UNITED STATES PATENT AND TRADEMARK OFFICE

10/748,535

Office Action Summary	Application No. 10/748,535	Applicant(s) WEVERKA ET AL.	
	Examiner Sung H. Pak	Art Unit 2874

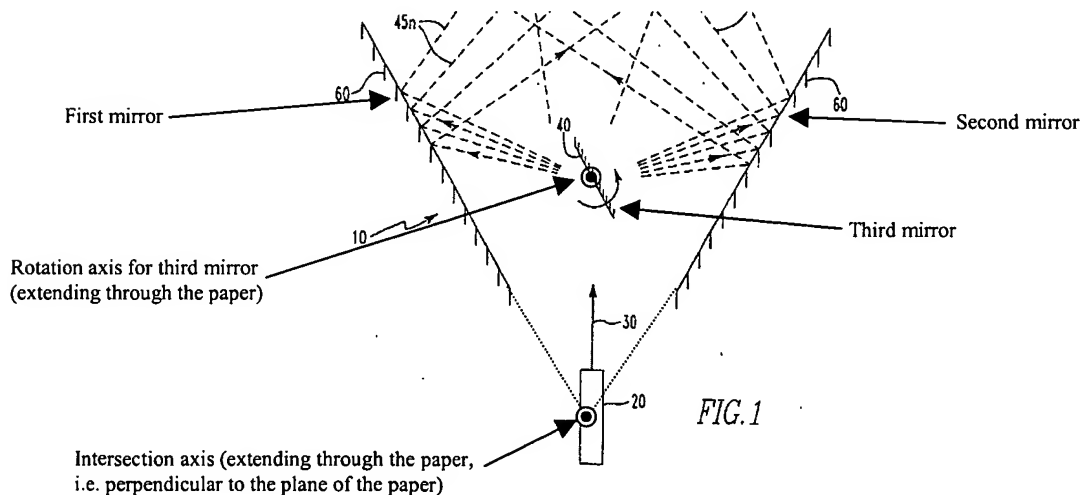
Claim 30 is rejected under 35 U.S.C. 102(b) as being anticipated by Welch (US 5,565,686).

Welch discloses an optical device with all the limitations set forth in the claims including: first and second flat mirrors, fixed at a particular included angle with respect to one another (figure above); said first and second flat mirrors defining an intersection axis (figure above); a third flat mirror mounted for rotation about a rotation axis parallel to the intersection axis (these axes are parallel as shown in the figure above); an actuator coupled to the third flat mirror configured to provide first and second angular positions about the rotation axis (column 4 lines 51-53); the first angular position being such to define an included angle of approximately 90 degrees between the first and third flat mirrors, the second angular position being such to define an included angle of approximately 90 degrees between the second and third flat mirrors (column 4 lines 51-53, column 4 lines 39-42). Since the third mirror rotates 360 degrees, first and second angular positions that define 90 degrees angle is inherently disclosed.

FIG. 4

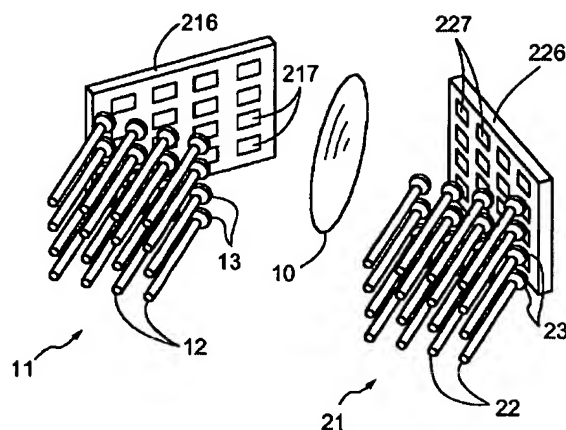
Claim 31 is rejected under 35 U.S.C. 102(e) as being anticipated by Kalman et al (US 6,424,756 B1)

Kalman discloses an optical device with all the limitations set forth in the claims including: a support element having first and second mounting surfaces lying in planes defining an angle therebetween of approximately 90 degrees ('216', '226' figure above); first and second MEMS micromirror arrays disposed on respective first and second substrates, mounted to the first and second mounting surfaces of the support element ('217', '227'; column 7 lines 29-30); a given micromirror in the first array being associated with a plurality of M micromirrors in the second array (column 7 lines 21-25); an actuator coupled to each given micromirror in the first array to provide M discrete orientations of the given micromirror, each orientation directing light along an incident direction toward different micromirror in the second array (column 7 lines 21-28); the plurality of M micromirrors in the second array having respective orientations such that each respective orientation is substantially 90 degrees to the orientation of the given mirror in the first array when the given mirror is oriented to direct light to that micromirror in the second array (see figure above). Since the input and output fibers ('12' and '22') are arranged in parallel, the orientation of the first mirror array is necessarily 90 degrees with respect to the orientation of the second mirror array in order to transmit light beam from the input fibers to the output fibers.
